## *City of El Paso – City Plan Commission Staff Report*

**Case No:** SUSU13-00027 Tierra Del Este 76  
**Application Type:** Major Preliminary  
**CPC Hearing Date:** May 30, 2013  
**Staff Planner:** Nelson Ortiz, (915) 541-4931, [ortiznx@elpasotexas.gov](mailto:ortiznx@elpasotexas.gov)  
**Location:** North of Pebble Hills and East of John Hayes  
**Acreage:** 86.09 acres  
**Rep District:** 5  
**Existing Use:** Vacant  
**Existing Zoning:** R-5  
**Proposed Zoning:** R-5  
**Nearest Park:** Linear park proposed within subdivision  
**Nearest School:** Adjacent to future school site  
**Park Fees Required:** N/A  
**Impact Fee Area:** A portion located within Eastside Impact Fee Service Area.  
**Property Owner:** Ranchos Real XIV, LLC  
**Applicant:** Ranchos Real XIV, LLC  
**Representative:** Conde, Inc.

# TIERRA DEL ESTE UNIT SEVENTY SIX

TIERRA DEL ESTE UNIT SEVENTY SIX

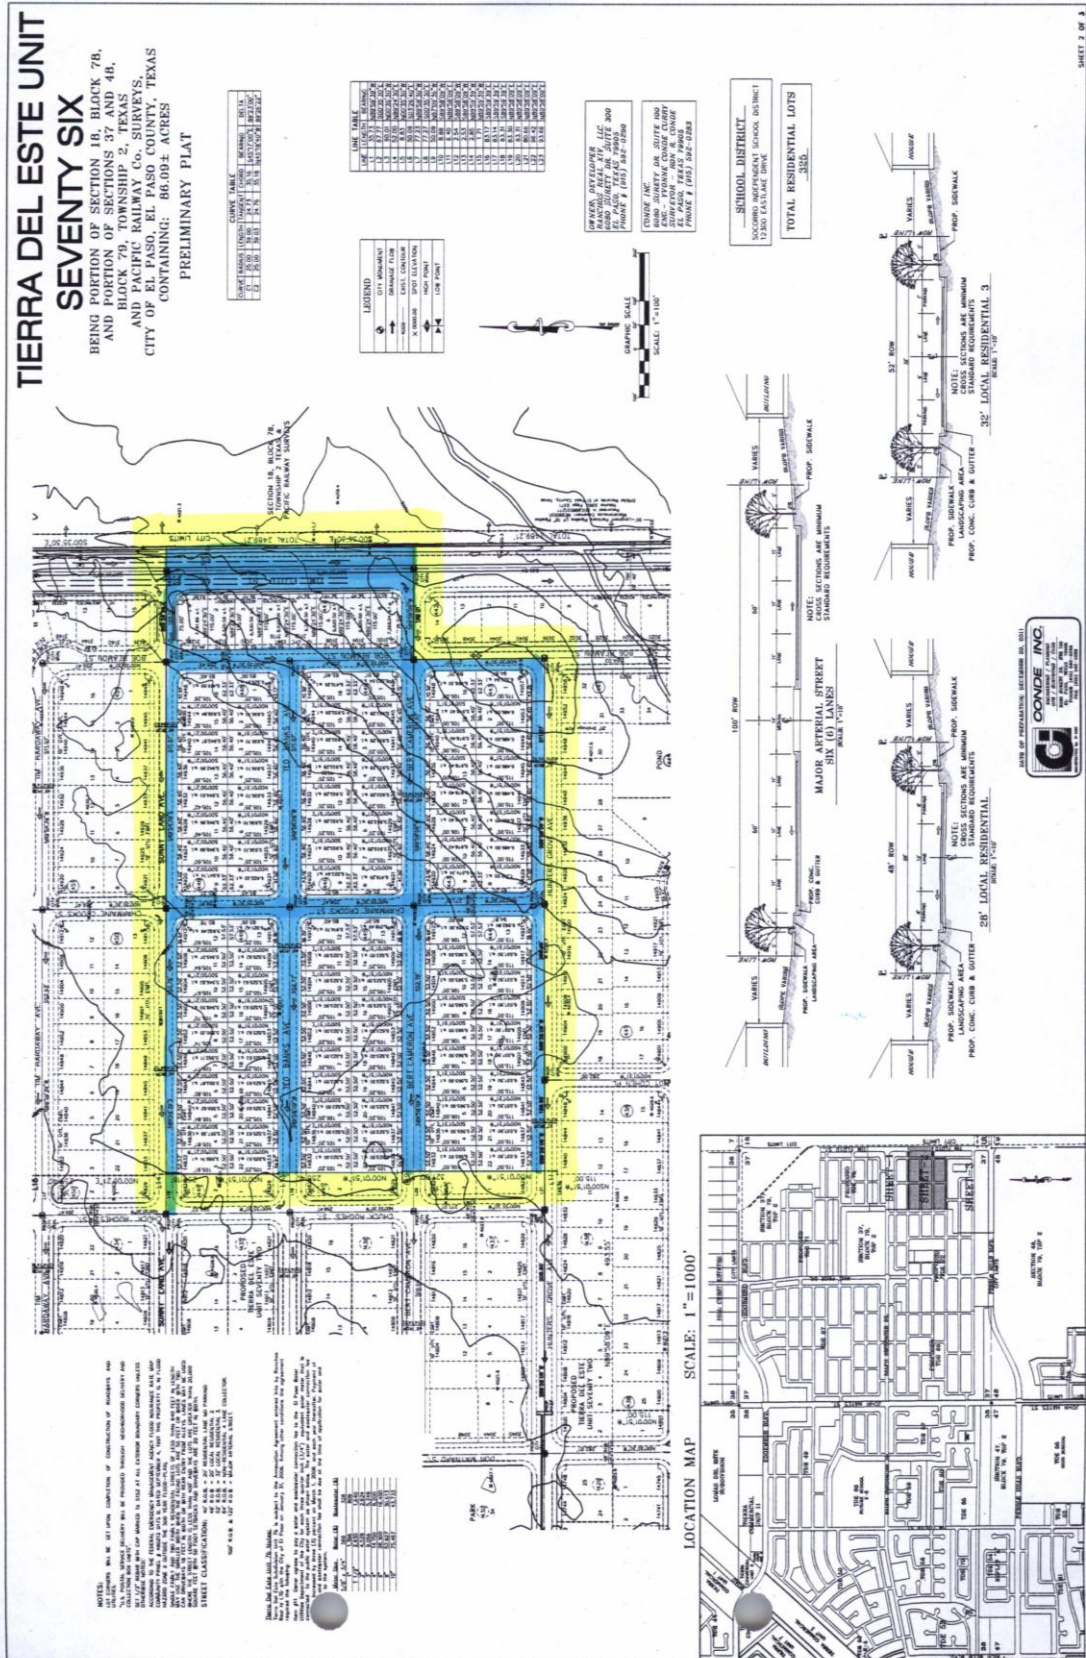
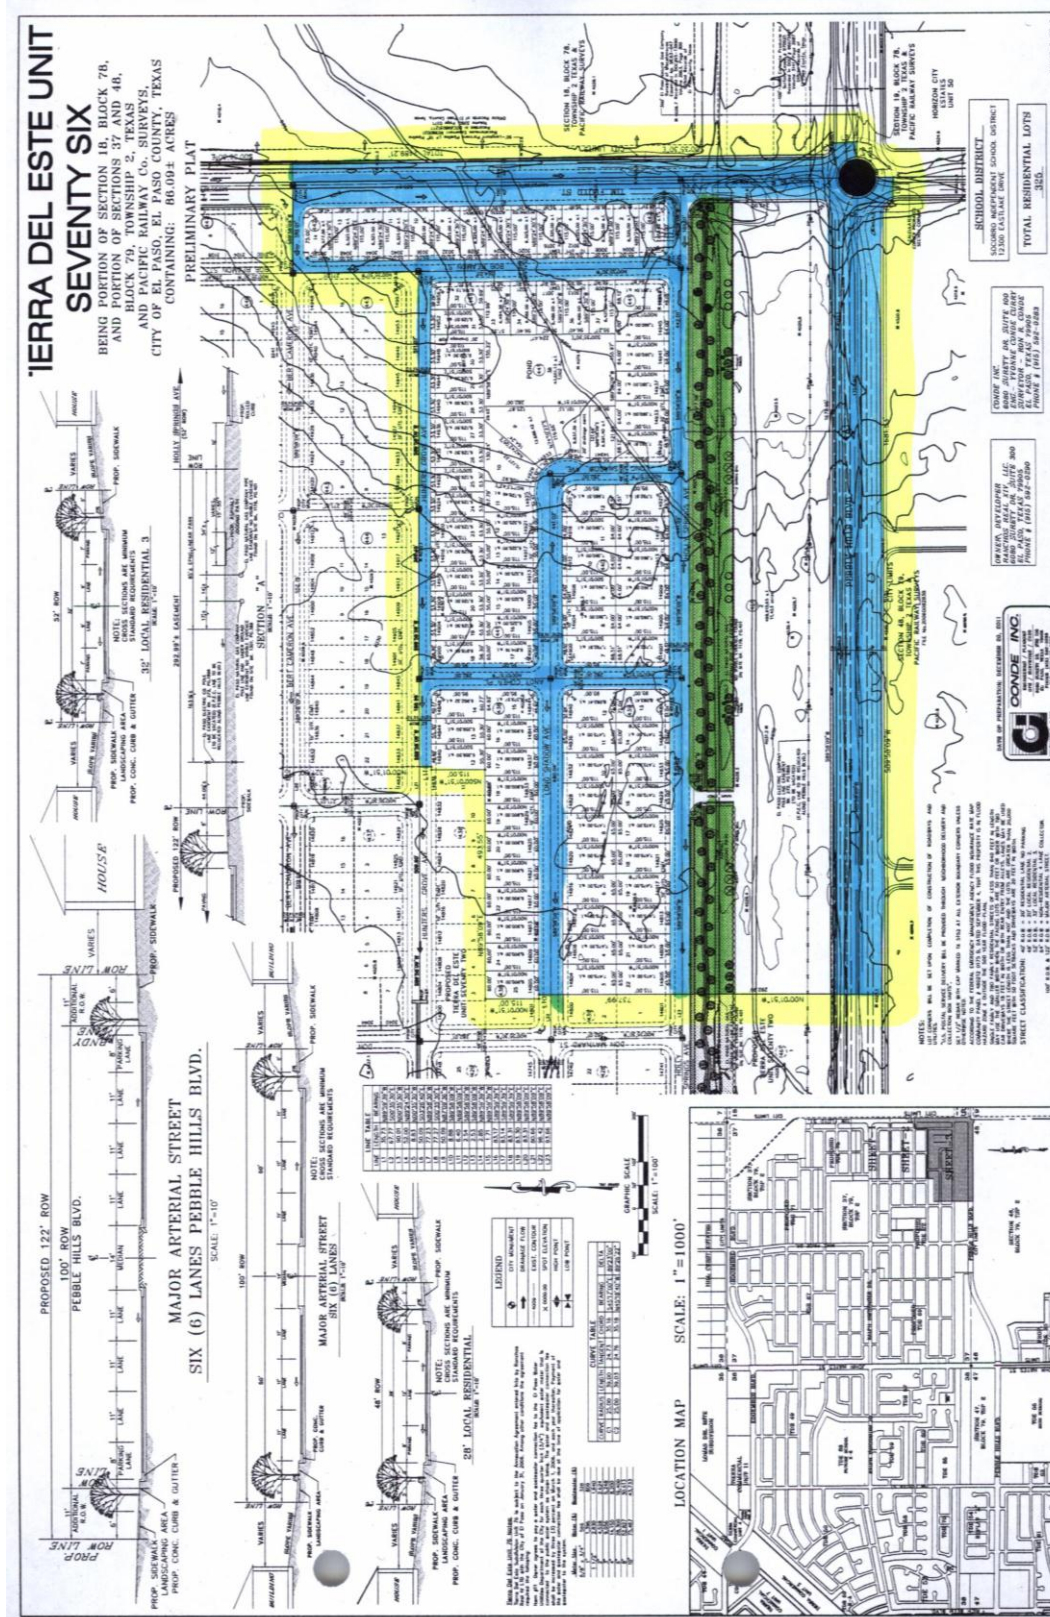
1. On the preliminary plat, provide direction of flow of all watercourses, location, type, material and size of any existing and proposed storm water drainage structures or facilities.

2. As per section Code 18.08.010, section D, all drainage structures and ponding areas serving the subdivision are constructed as part of the initial phase of the development.

3. Tim Floyd shall be constructed to City standards to include the full width of the street at all locations abutting the development and improvements shall be included in the subdivision improvement plans.

4. Pebble Hills Blvd. shall be constructed to City standards to include the full width of the street at all locations abutting the development and improvements shall be included in the subdivision improvement plans.

5. Traffic calming devices at the intersections of Tim Floyd St. and Ralph Seitsinger Dr. and Tim Floyd St. and Pebble Hills Blvd. shall be constructed fully within the subdivision boundaries.

6. Provide and label legal access to the Subdivision.
7. All existing and/ or proposed paths of travel (accessible sidewalks, wheelchair and driveways) located within the public rights-of-way shall be constructed in accordance with the current City Design Standards for Construction and be ADA/TAS compliant.

- Double frontage lots along Tim Floyd shall comply with Section 19.23.040.H (Double Frontage Lots).
